APPEAL SUMMARY

| Appeal ID: 20528 | Project Address: 3111 SE Powell Blvd |
| Building/Business Name: Cleveland High School | Fire Sprinklers: No |
| Plan Submitted Option: pdf [File 1] | Proposed use: baseball practice facility |

SITE PLAN
CLEVELAND HS BASEBALL FACILITY
 PORTLAND, OREGON

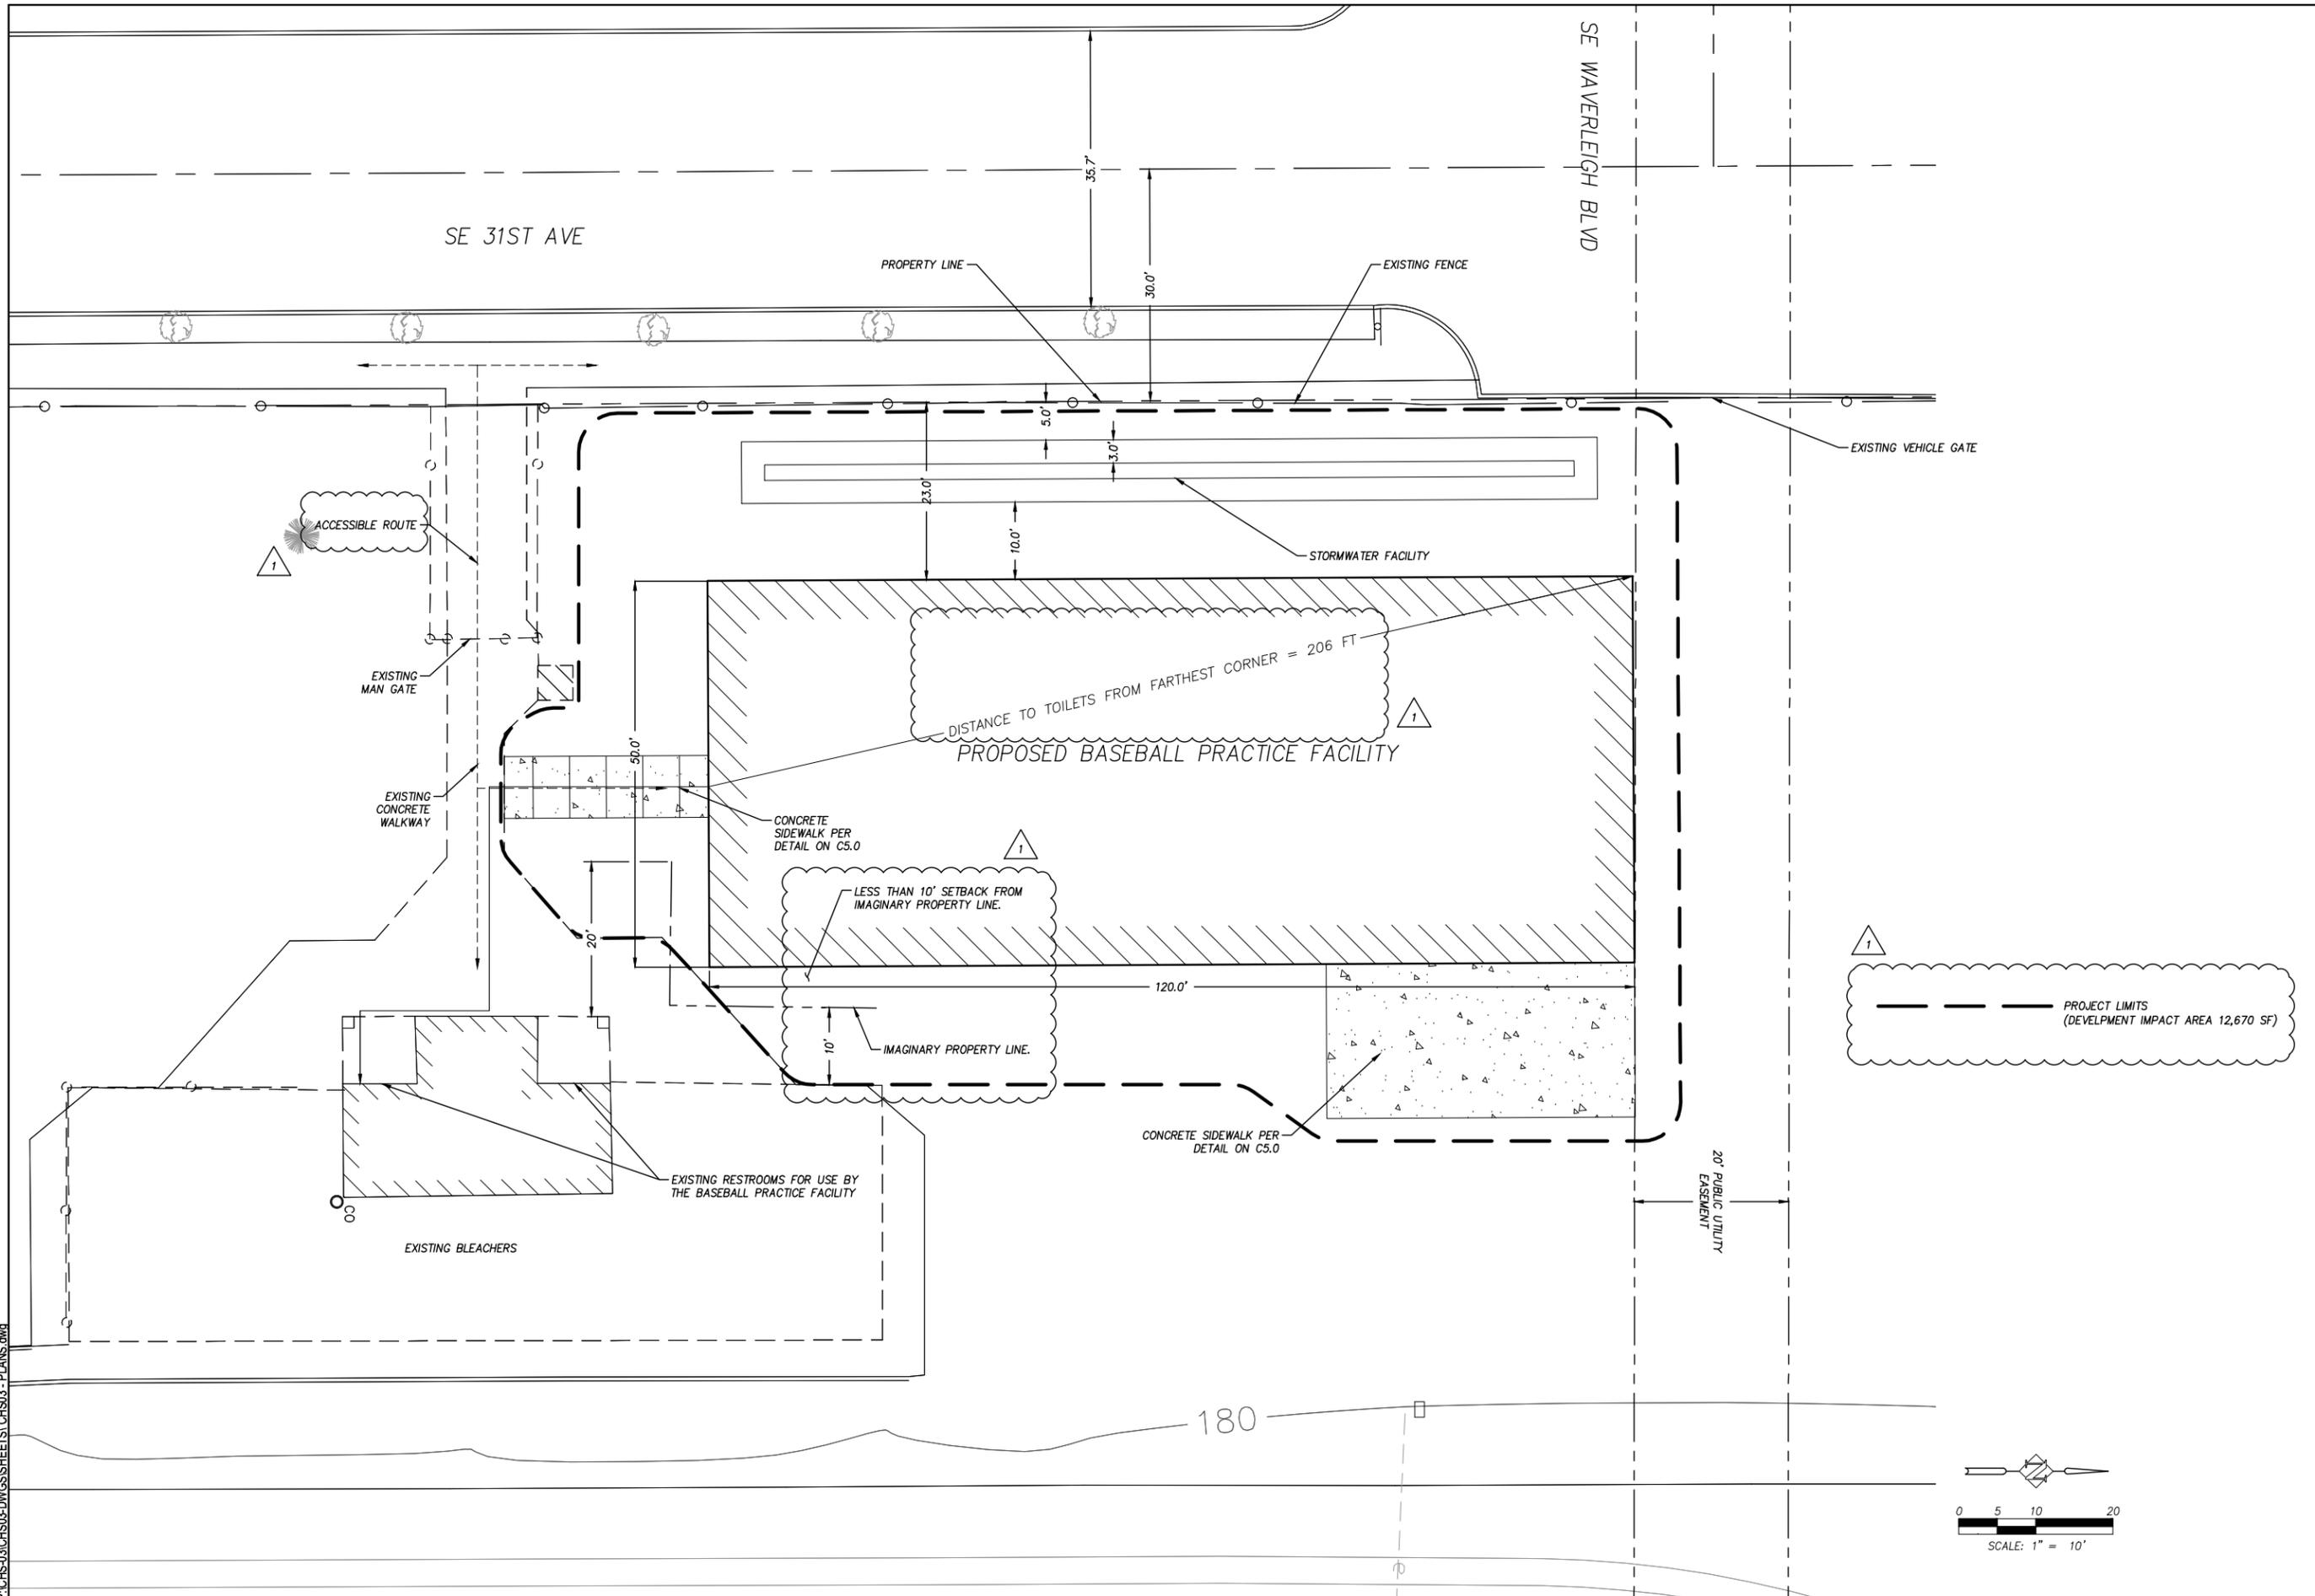
The proposed building is a baseball practice facility. No restroom facilities are proposed within the new building. The building is located on the existing Cleveland High School Field site and within 500 feet of the existing restrooms located in the grandstands. See attached plan showing location and route to restrooms. The proposed practice facility building will replace existing outdoor practice space that currently utilizes the restroom facilities within the grandstands. The occupancy of the proposed baseball practice facility is 120. See below table for required restroom fixtures per table 2902.

See attached plan of the existing restroom facilities in the grandstands. This facility satisfies the requirement for the number of fixtures for the proposed building. The bathrooms located in the grandstand will be open and available for use when the baseball practice facility is occupied. The route from the proposed building to the restrooms is ADA accessible. The proposed building use will not overlap with events at the field. See separate code appeal related to the shared use of the bathrooms.

1. Grandstand toilet facilities to serve baseball practice structure: Granted as proposed.**2. Reduction in minimum required number of plumbing fixtures serving the Field property: Granted as proposed.**

FIELDHOUSE RESTROOMS

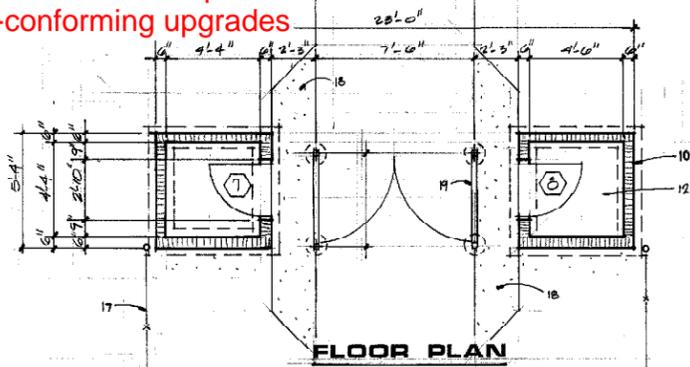
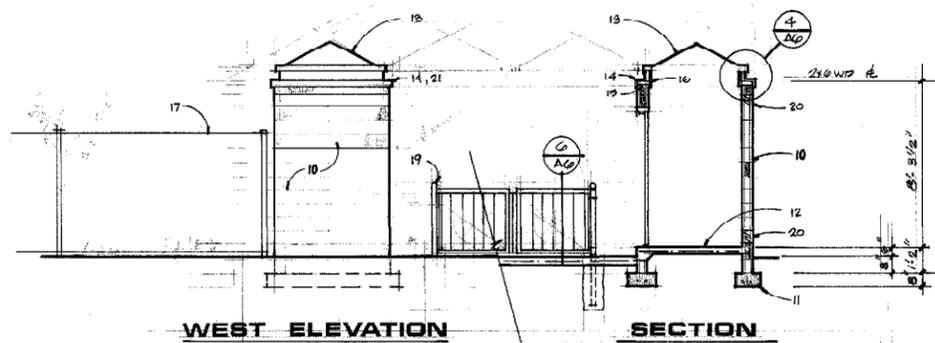
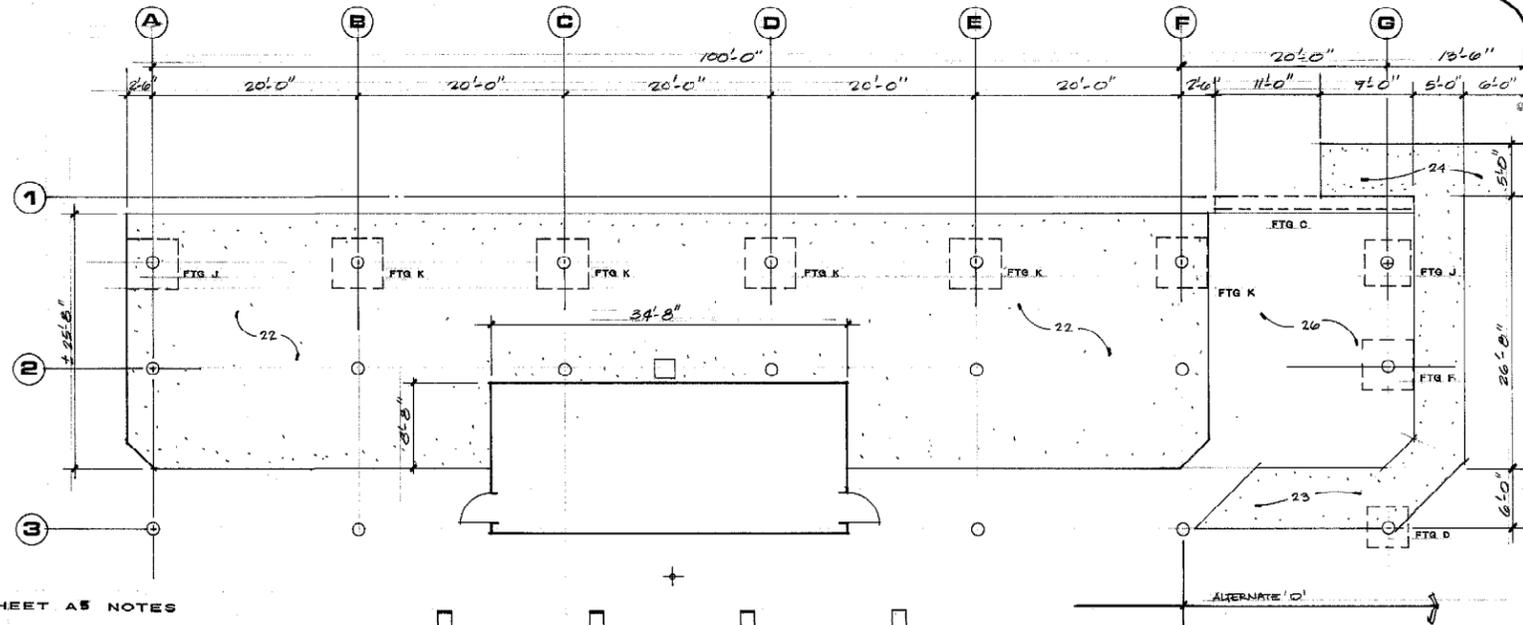
There are two buildings on the Cleveland High School Field property that have restroom facilities. The Cleveland High School main campus has additional restroom facilities but is located several blocks from the field. The following is a breakdown of the required number of restroom fixtures by building along with the required number of restroom fixtures based on the use. Note that the project proposes to restore the use of the women's facilities within the field house which were converted to storage.

The existing women's facilities have been converted to storage. The project proposes to restore these restrooms as part of non-conforming upgrades
